CERTIFICATE OF APPROPRIATENESS

Applicant: Wyatt Parker, owner and Gamaliel A Yepes, agent

Property: 820 Fugate St, Lot 5, Block 205, East Norhill Subdivision. The property includes a historic 1,368 square foot, one-story wood frame single-family residence and detached garage situated on a 5,512 square foot interior lot.

Proposal: Alteration – Addition at rear and replacement windows at side/ rear (some alteration of openings)

CURRENT AERIAL VS. 1950s SANBORN MAPS – existing rear corner is not original*

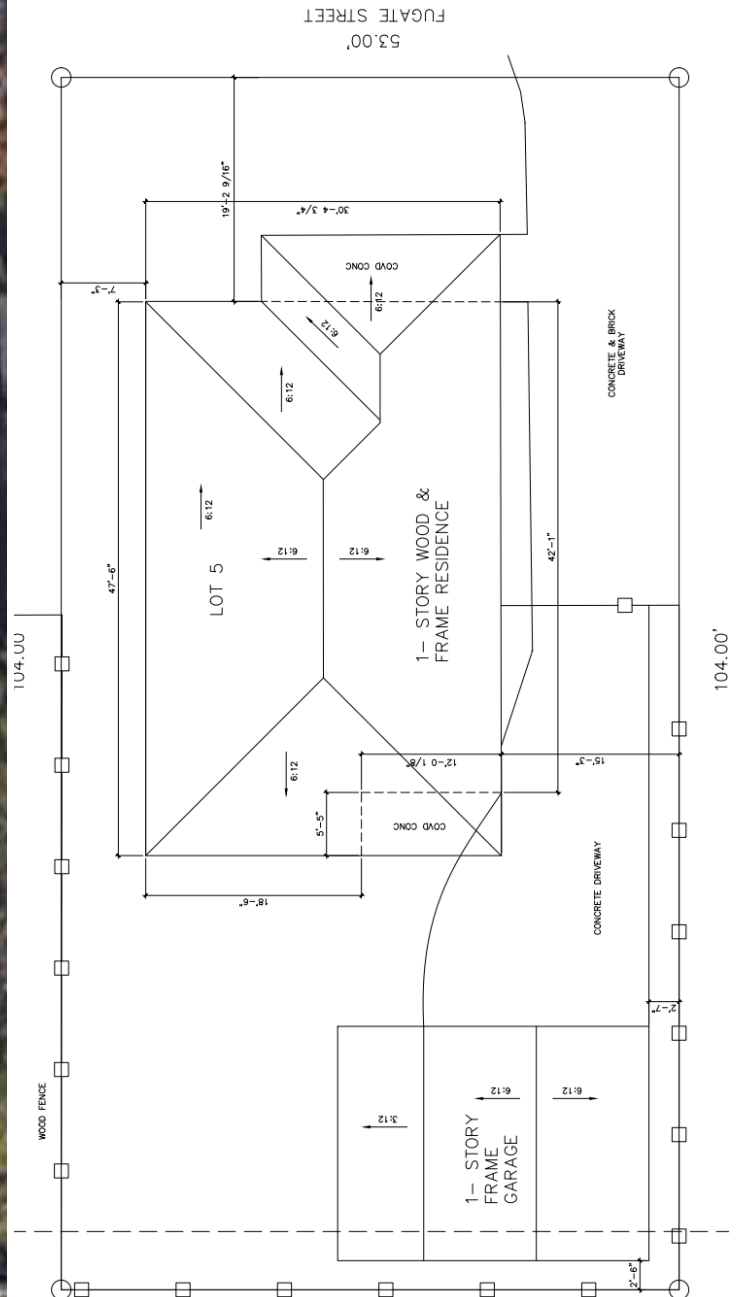
- Existing footprint and rear corners of home are not original – see c. 1950s Sanborn map.
- Applicant proposes rear addition of 12’3” x6’ (about 72sq feet) for a bathroom that does not change the roof plan and aligns with existing rear building line and foundation of home, maintaining setbacks from the property line.

WEST SIDE ELEVATION
EXISTING

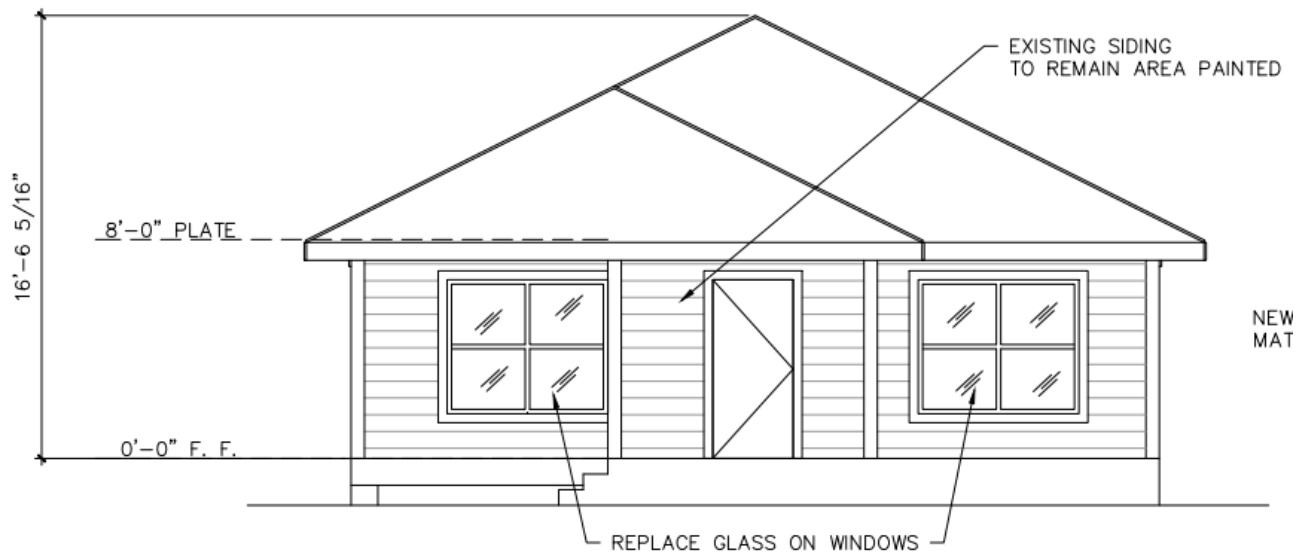
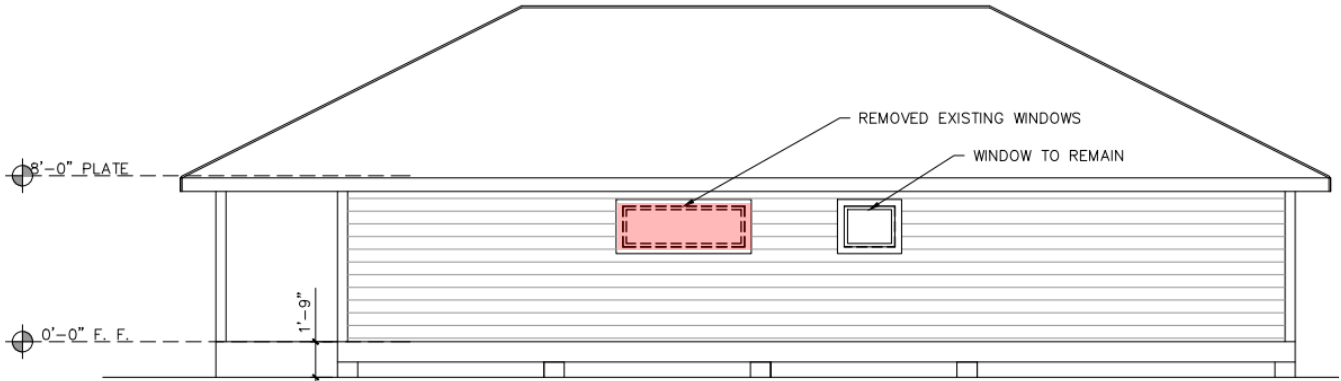
- Right (west) side elevation: existing replacement aluminum windows to be replaced. Front window J to remain same size opening, replace with wood window. Windows H and I existing replacement aluminum windows to be replaced with paired 1/1 wood windows in enlarged opening.

EAST SIDE ELEVATION

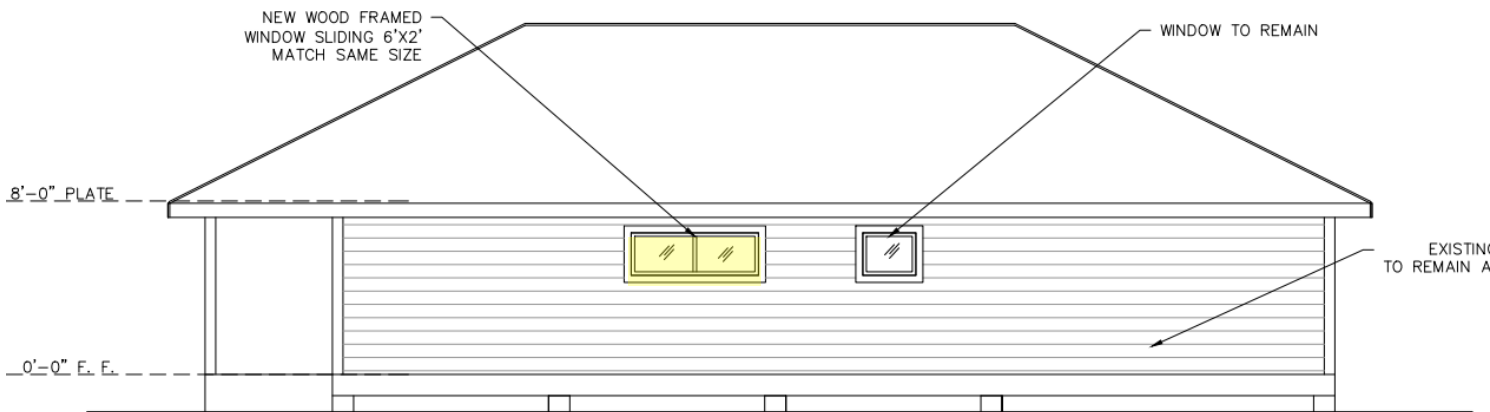
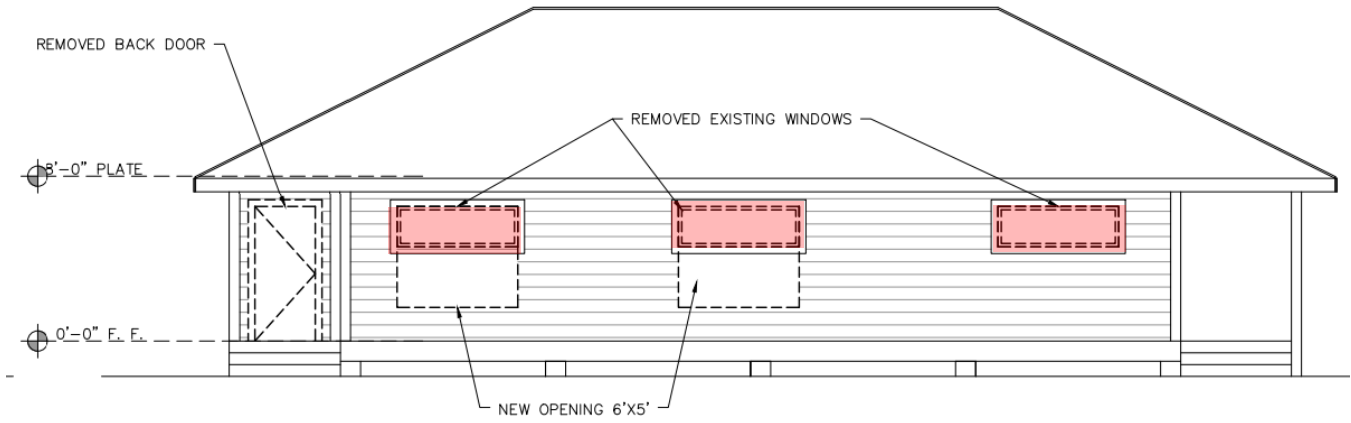
- Left (east) side elevation: replacement aluminum window C replaced with wood window in same opening. Window D to remain
- Rear windows and door alterations exempt
